MILTON MUNICIPAL UTILITY COMMISSION
CABELL COUNTY, WEST VIRGINIA

CONTRACT #2 – SANITARY SEWER REHABILITATION AND LIFT STATION
RELOCATION

ADDENDUM #2

FEBRUARY 10, 2022

SHEET No.
2

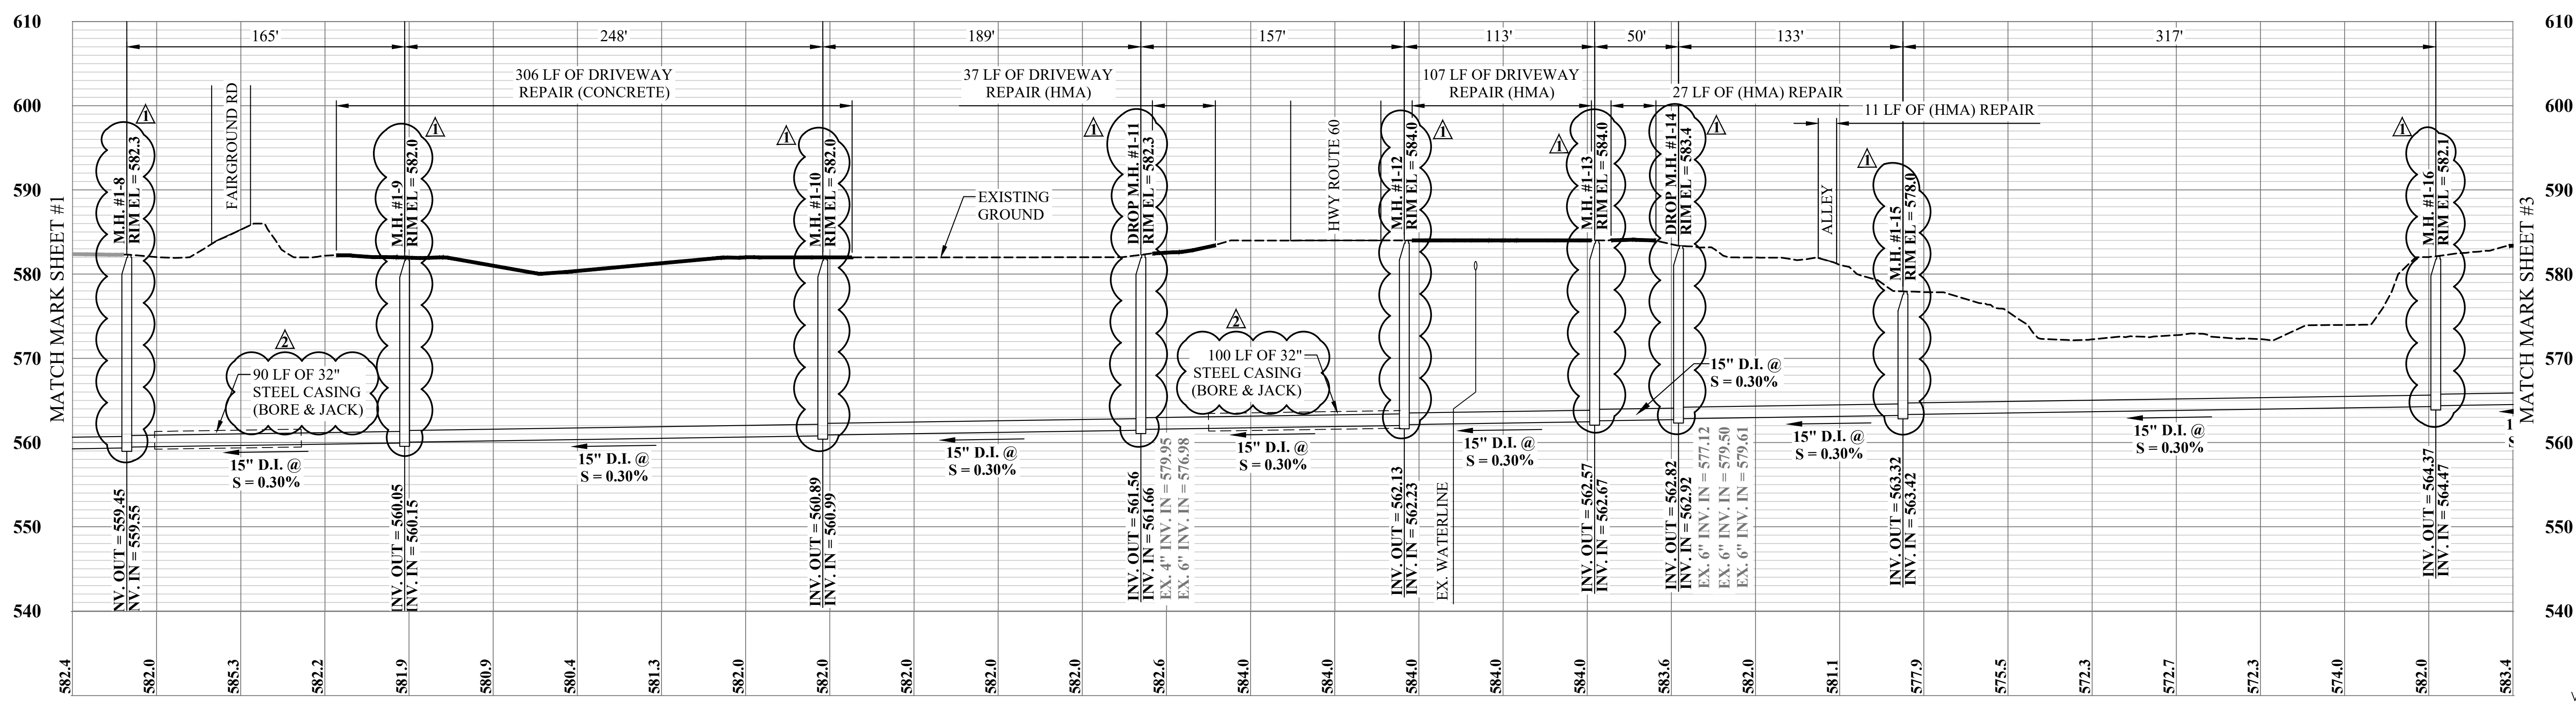
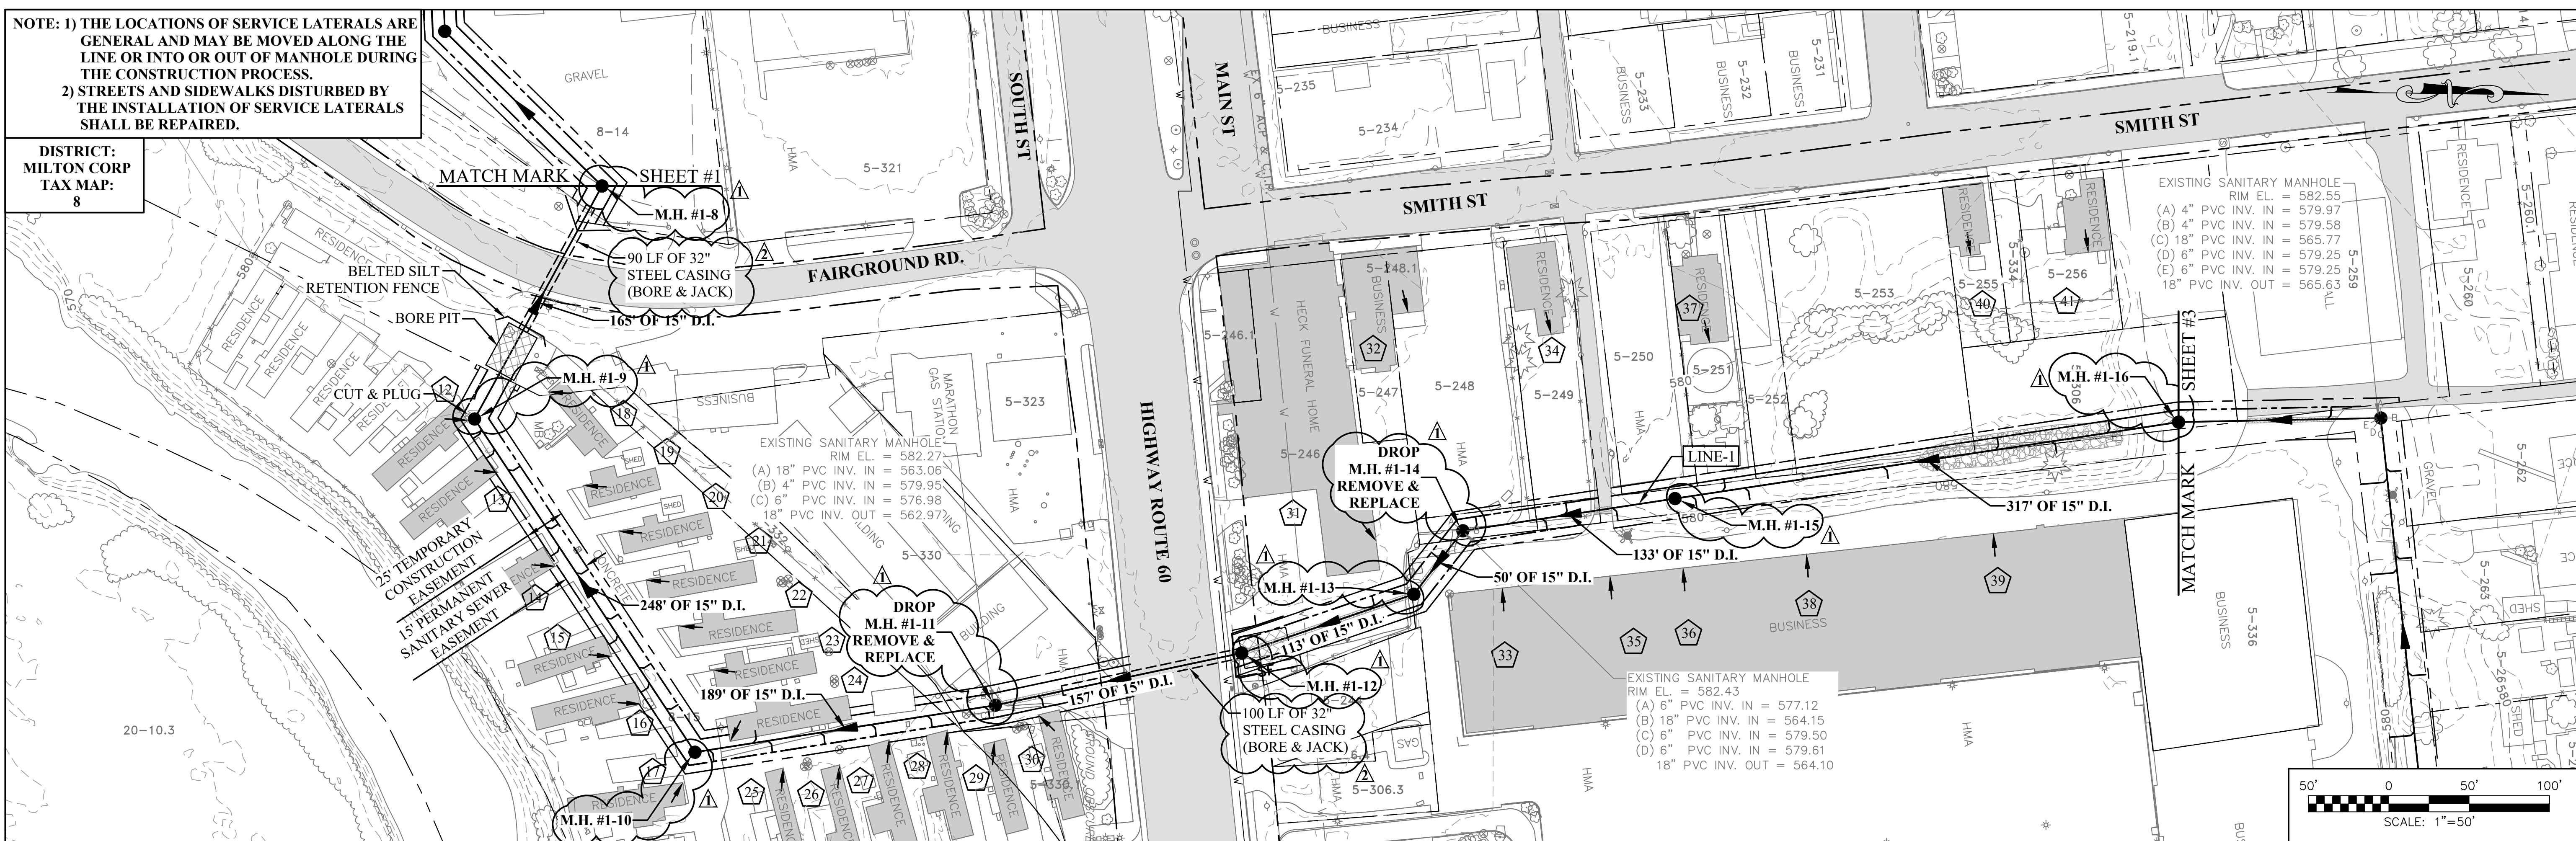
1. Can the trailer on Contract 2 Plan Sheet 2 between manhole 1-10 to 1-11 be moved so the sewer line can be installed? That line is very deep and very close to that trailer with numerous utilities in the way also

The easement for the project was not acquired with any discussion of moving the trailer. Movement of the trailer or alternative methods of construction of this line can be discussed during construction.

SHEET No.
E-1

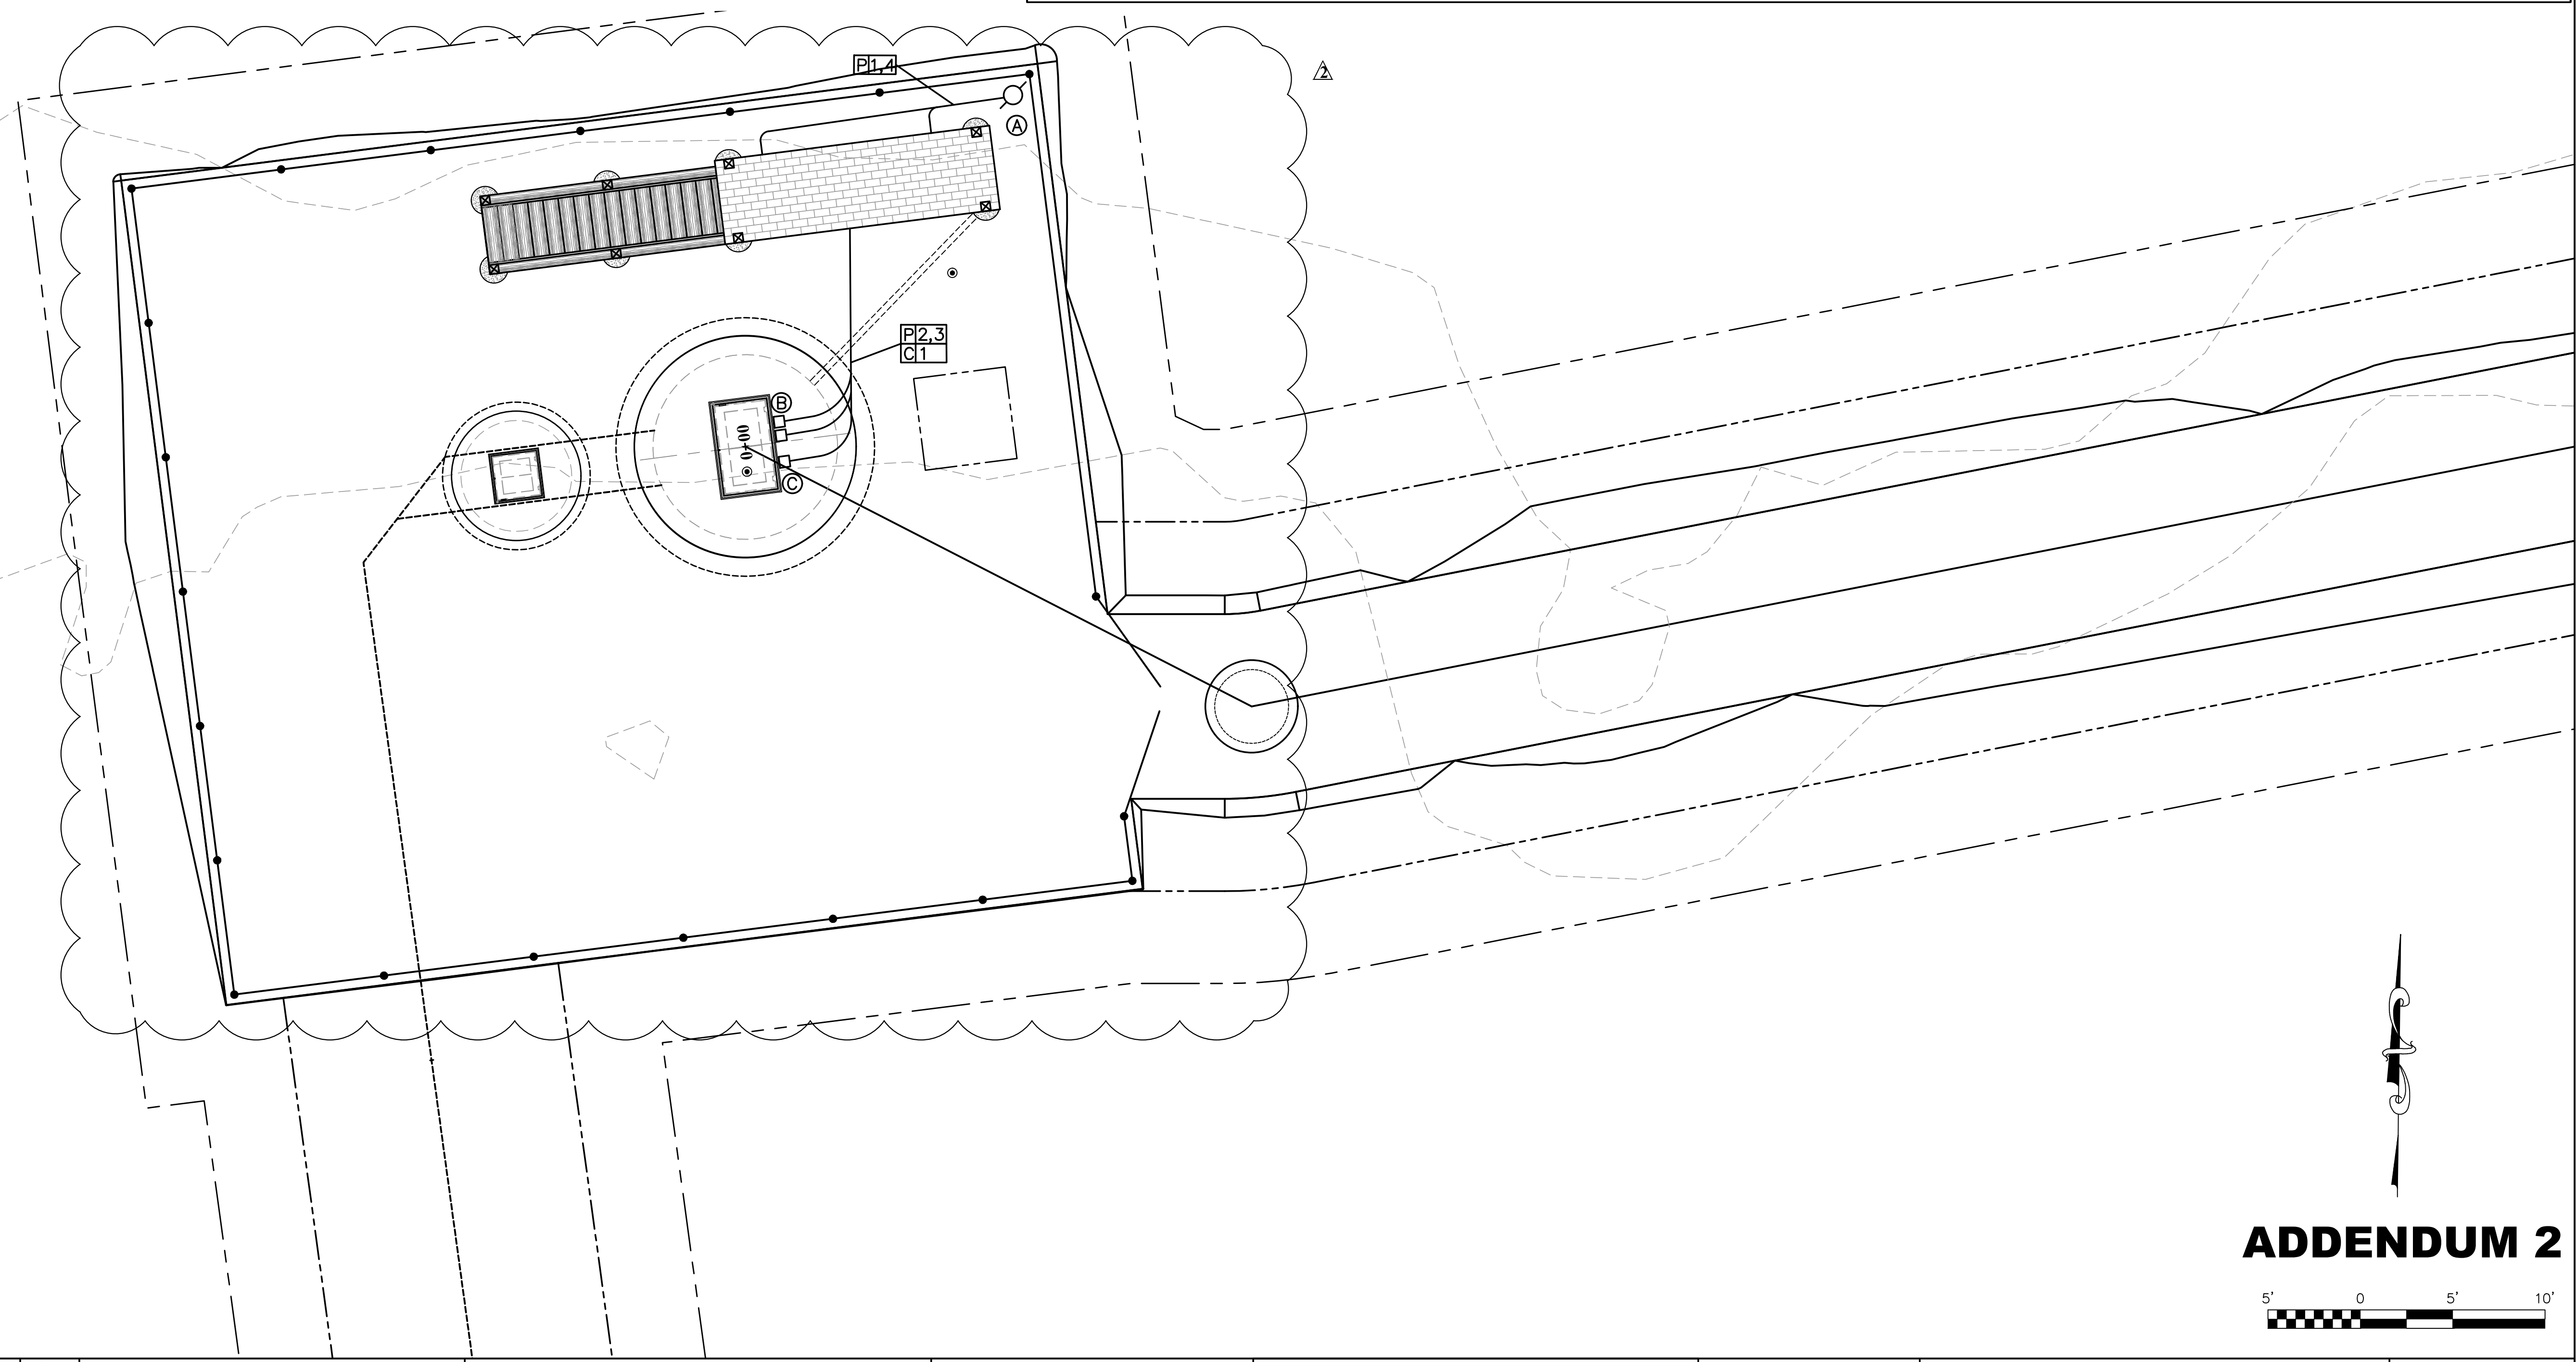
NO.	BY	DATE	DESCRIPTION
1	KMP	1/2022	ADDENDUM 1 - REVISED NOTE
2	CAS	2/2022	ADDENDUM 2 - UPDATED LIFT STATION AND WIRE SIZE

ELECTRICAL RISER DIAGRAM FOR SOUTH MAIN LIFT STATION
SCHEMATIC

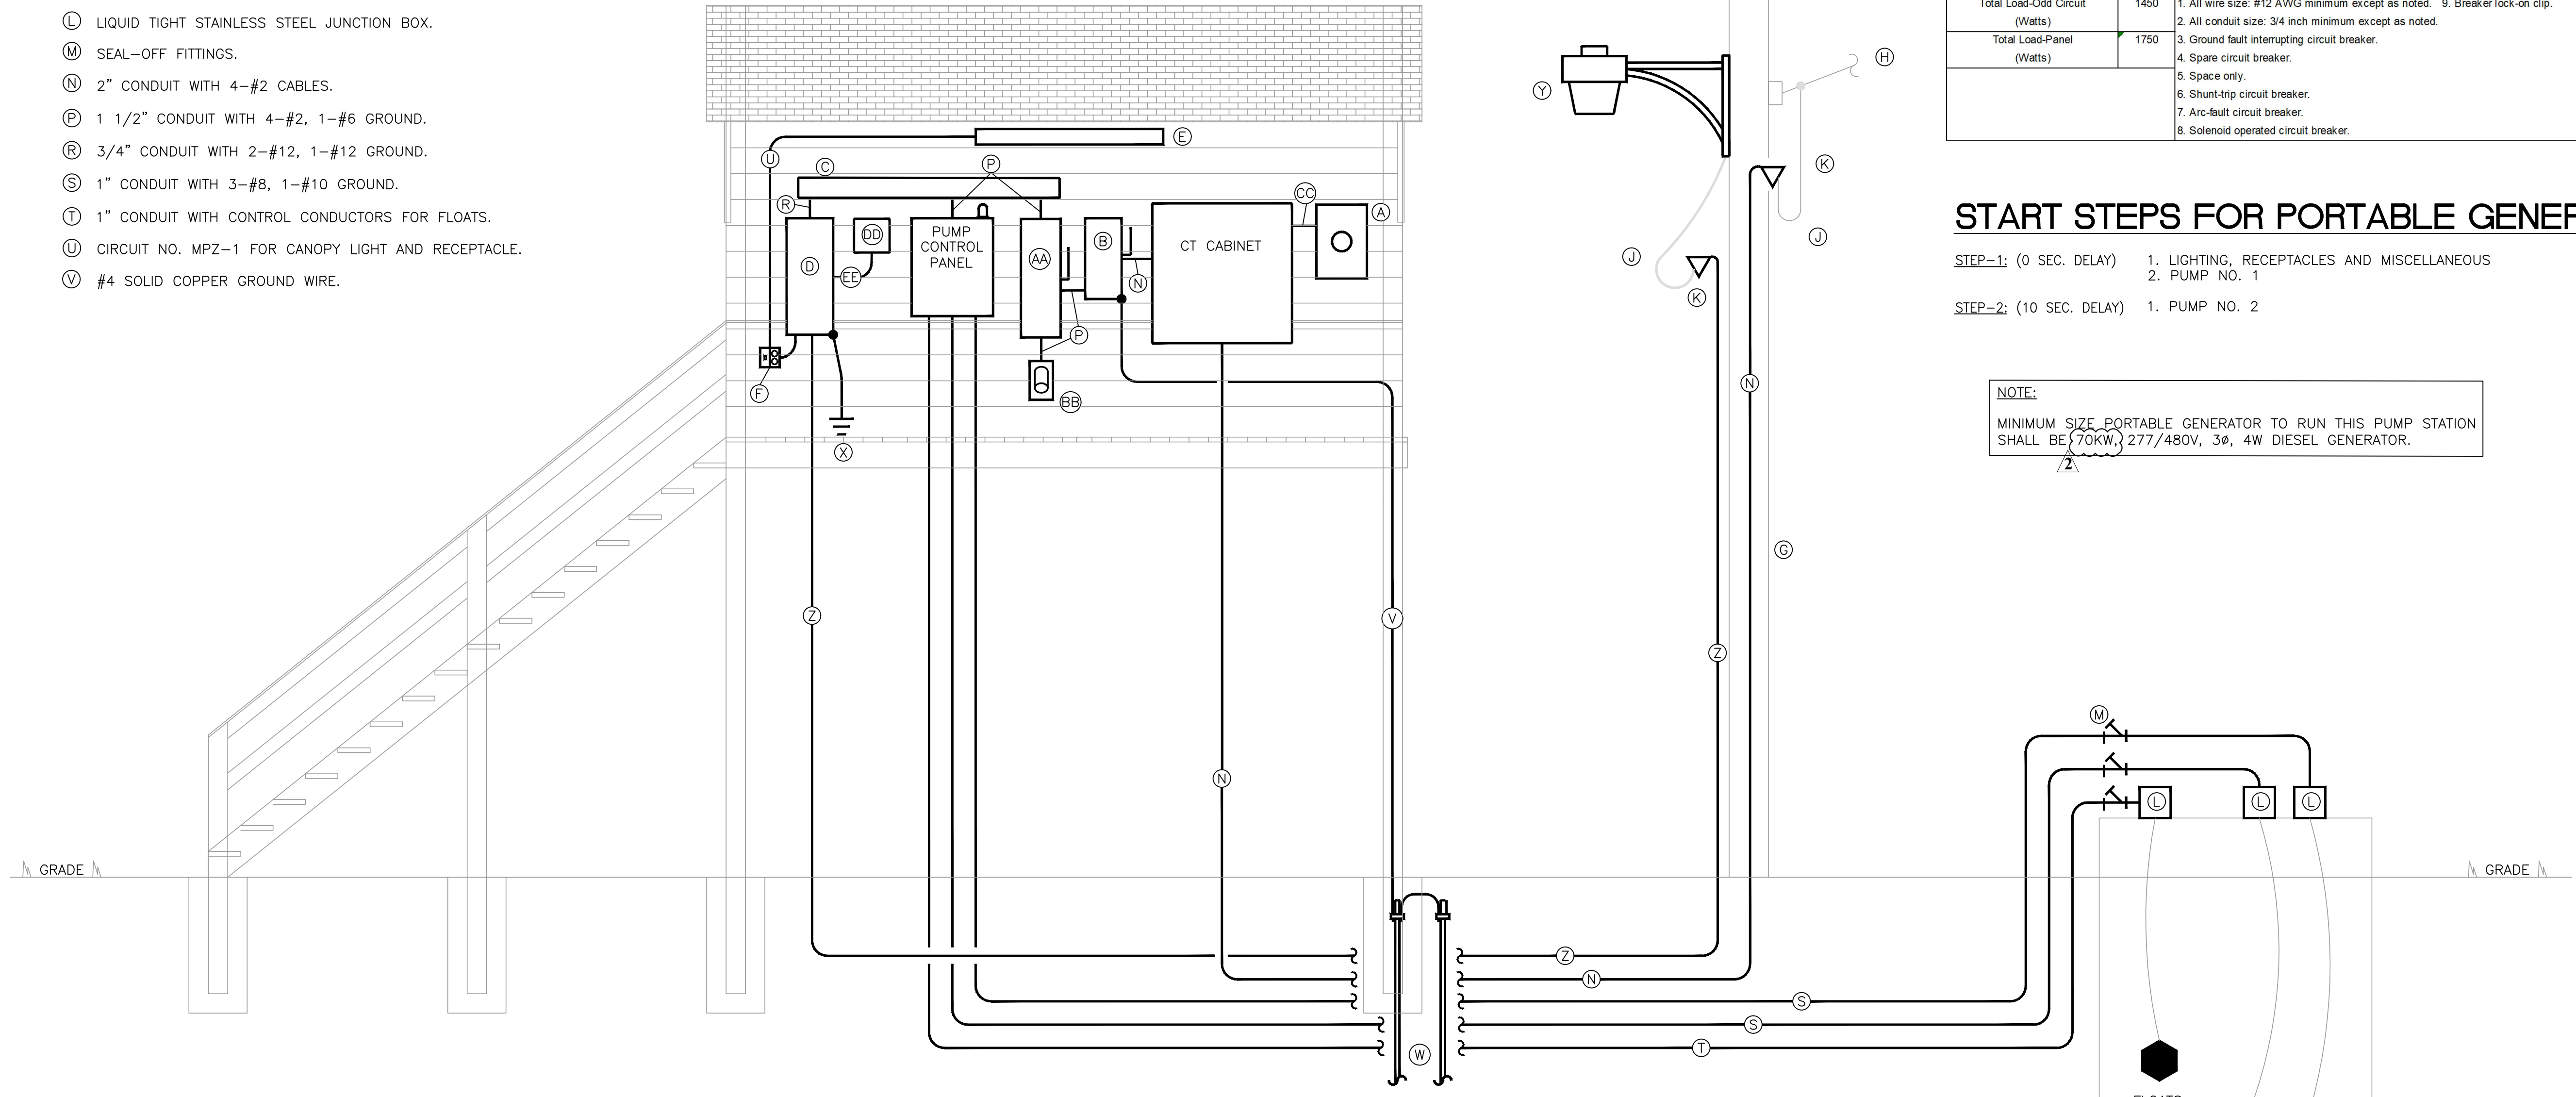
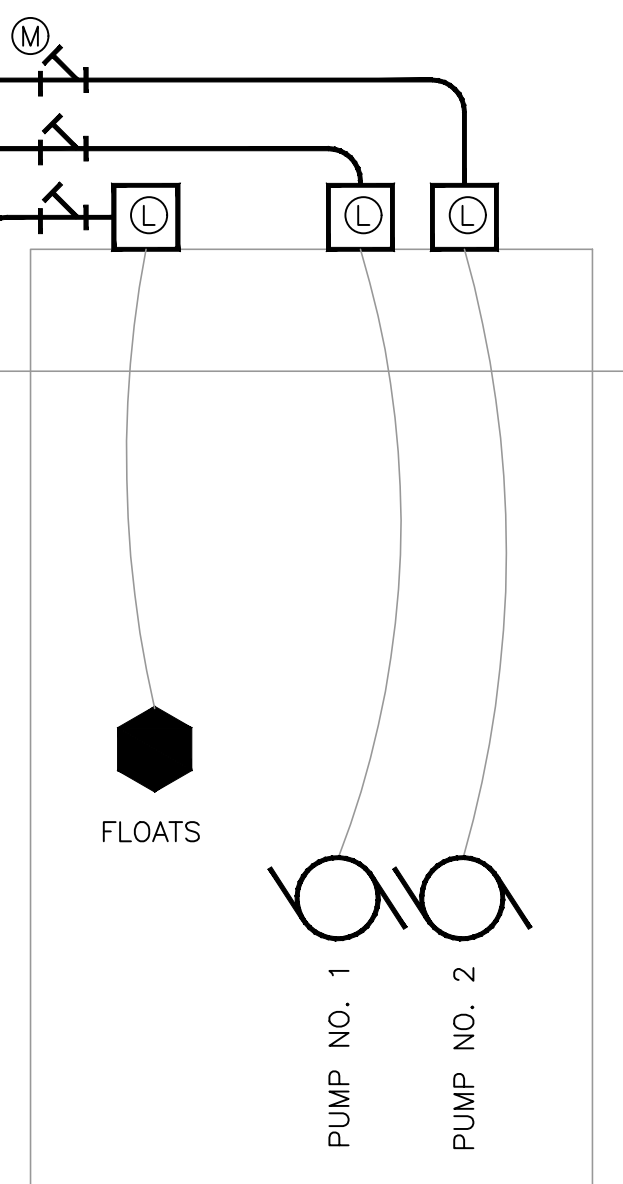
22. Can you verify the voltage for each station? Some say 230 volt but has a 480/120 volt control transformer and some drawings voltages font match the specs

NOTE:
MINIMUM SIZE PORTABLE GENERATOR TO RUN THIS PUMP STATION SHALL BE (70KW, 277/480V, 3Ø, 4W DIESEL GENERATOR.
